**Re: Vapor Intrusion Assessment Work Plan and Response
Former Signal Oil Marine Storage and Distribution Facility
(Chevron Bulk Plant 206127)
2301-2311 Blanding Avenue
Alameda, California
ACEH Case RO0002466**

ACEH TECHNICAL COMMENT 4

Response to Technical Comment 4

figure 3

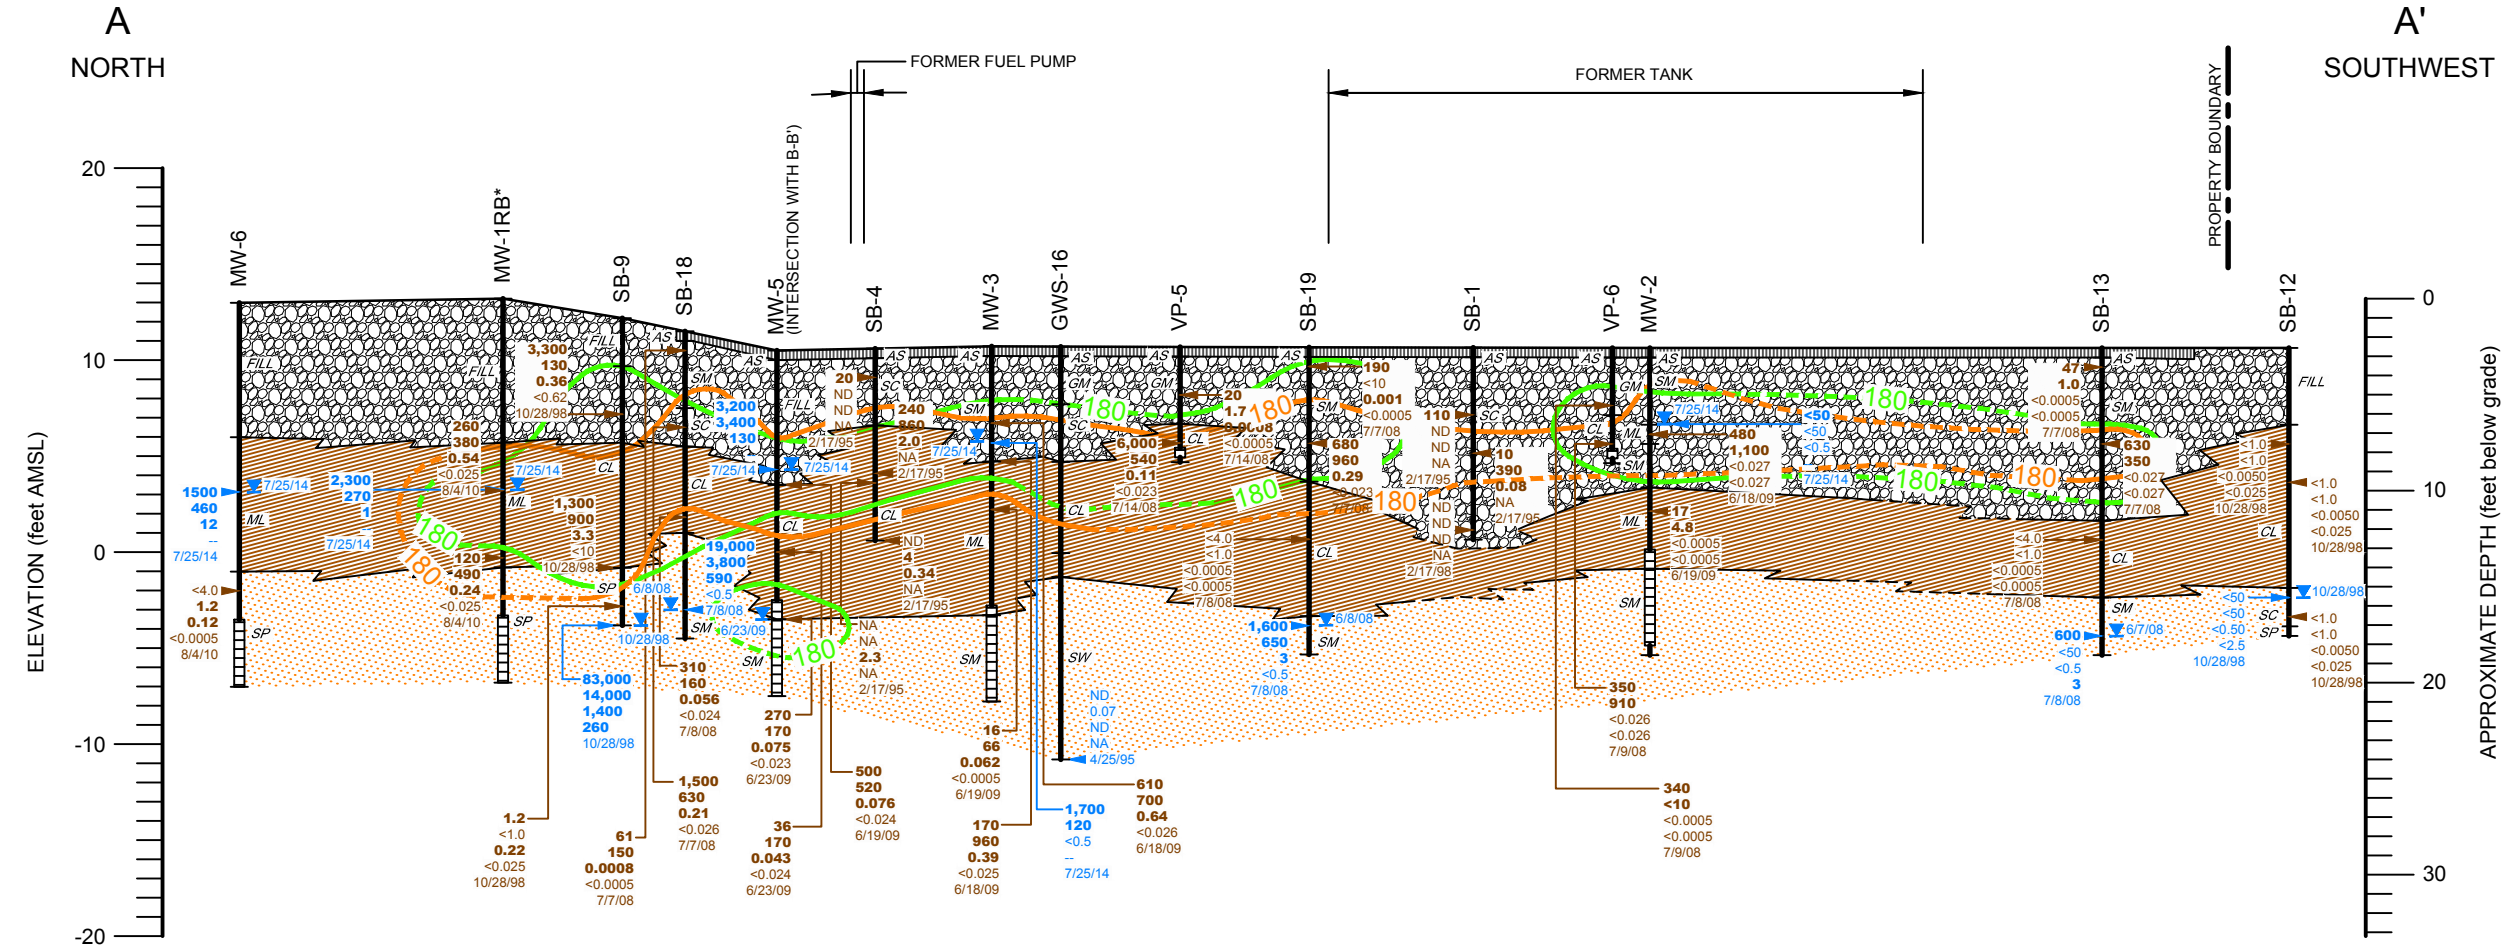
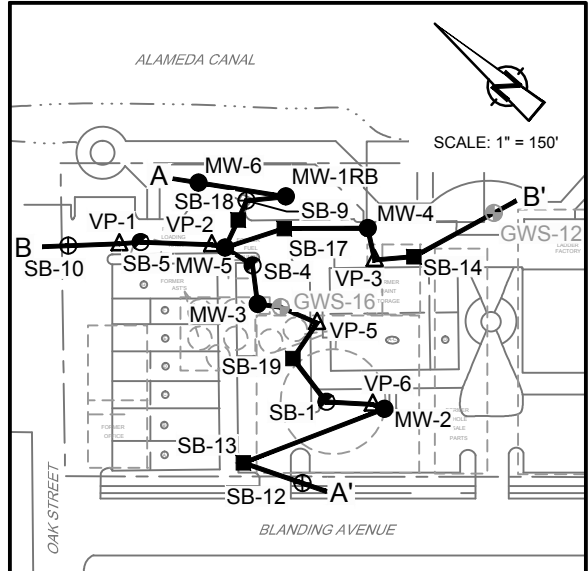
- 2. Connection and Discharges to Surface Water.** A review of cross sections for the site indicates that a layer of permeable sands and silts appears to extend from the site to the Alameda Canal. The 2012 tidal study confirmed that water levels in several monitoring wells at the site had strong responses to tidal fluctuations indicating that the site is hydraulically connected to the Alameda Canal. There appears to be a migration pathway for contaminated groundwater in well MW-1RB to the Alameda Canal. We do not concur that the site meets Class 5 of the groundwater-specific criteria. During the most recent groundwater sampling event, the concentration of total petroleum hydrocarbons as gasoline detected in groundwater from well MW-1RB was 1,300 micrograms per liter, which is the highest concentration detected historically for well MW-1RB. Since groundwater concentrations are not decreasing in some areas of the site and there appears to be a migration pathway to Alameda Canal, it is possible that the site represents a chronic source for petroleum hydrocarbons discharging to the adjacent surface water in the Alameda Canal. Groundwater sampling is to be continued on a semi-annual basis.
